SITE PLAN REVIEW

LOT NO 53 REGISTERED PLAN 43M-1981

OSTIENSE CITY OF BRAMPTON

SITING ELDERBRIDGE ROAD LOT 53

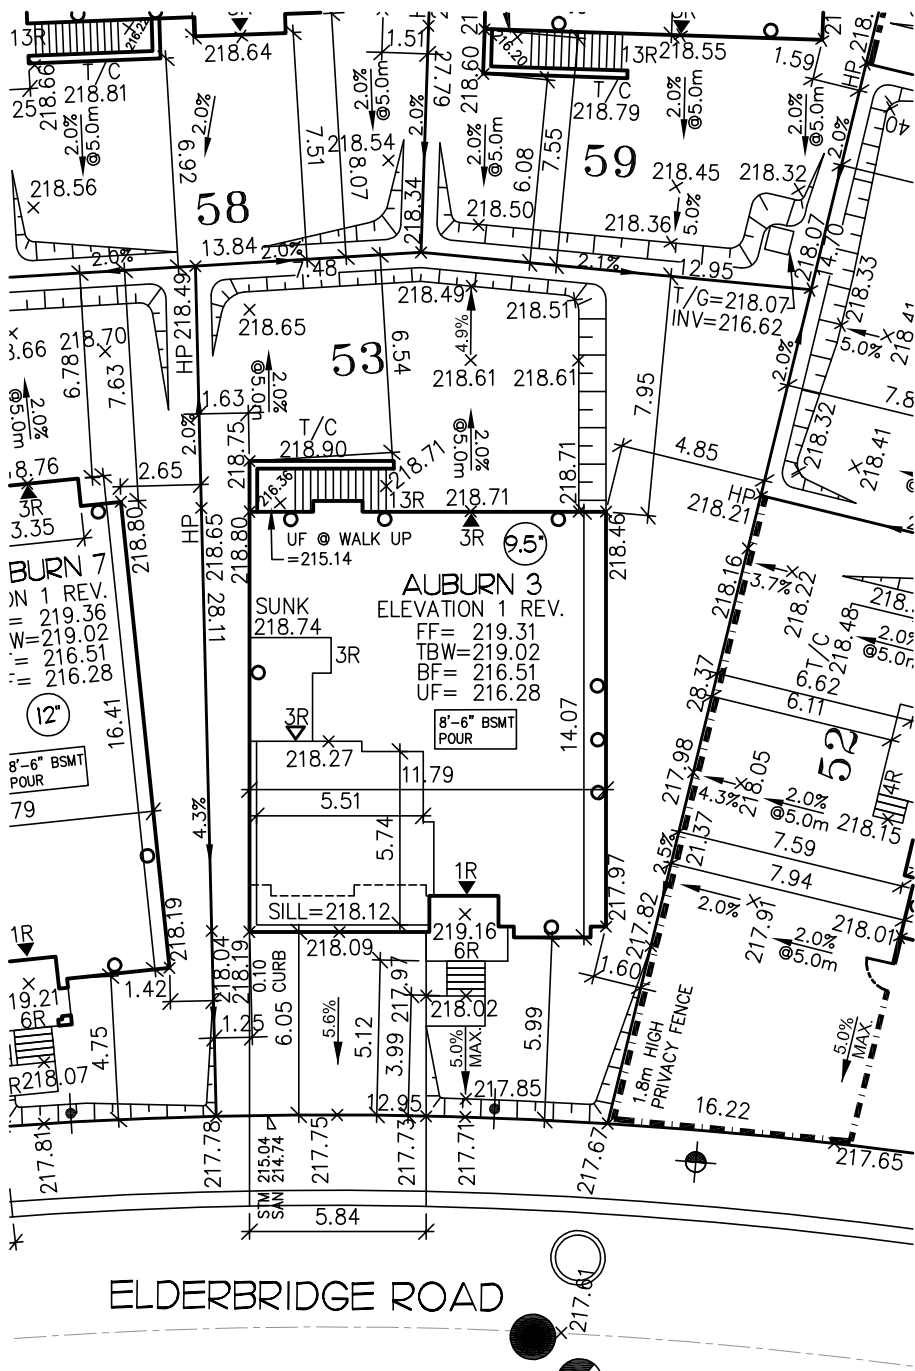
THE PROPOSED LOT GRADING AND DRAINAGE IS APPROVED AS BEING IN CONFORMITY WITH THE OVERALL APPROVED GRADING PLANS FOR THE SUBDIVISION.

NO COMMENT
